S4

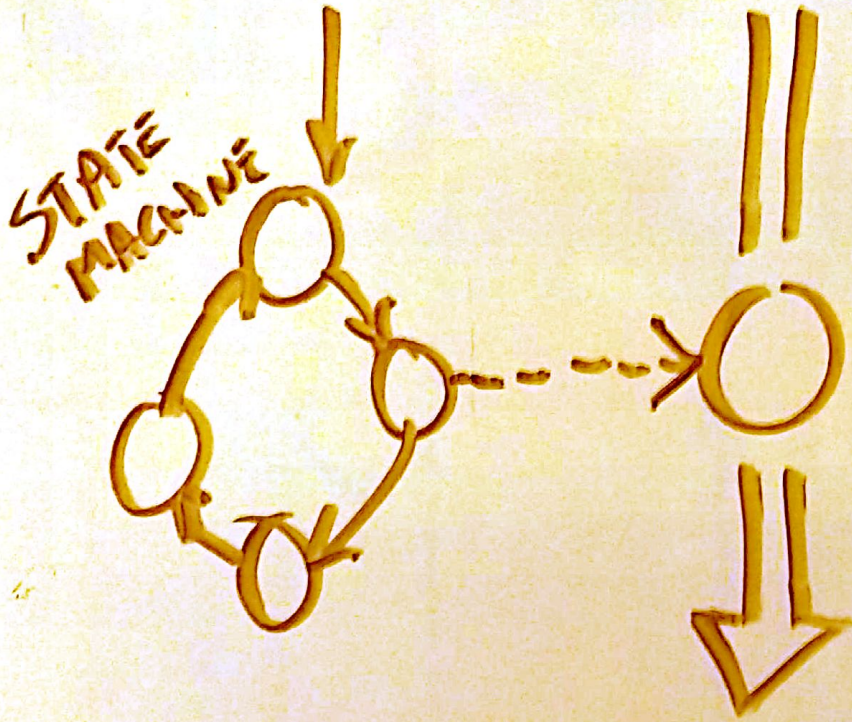
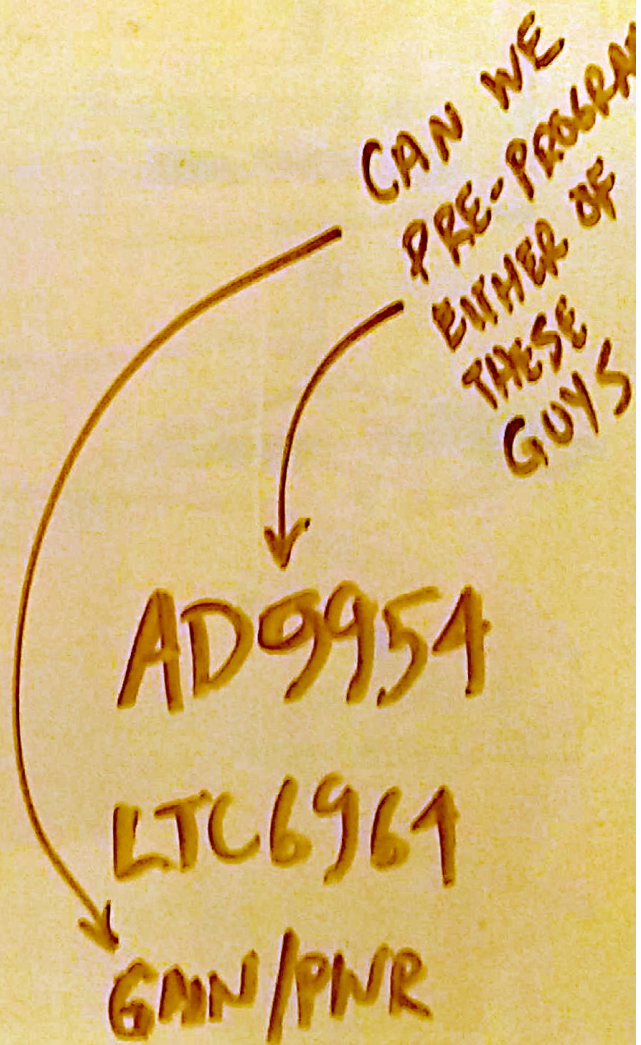
TIME BASE

LATENCY ASSOC  
W/ EACH SPI TARGET  
"SCHEDULING" ?

ONLY 1  
SPI BUS?
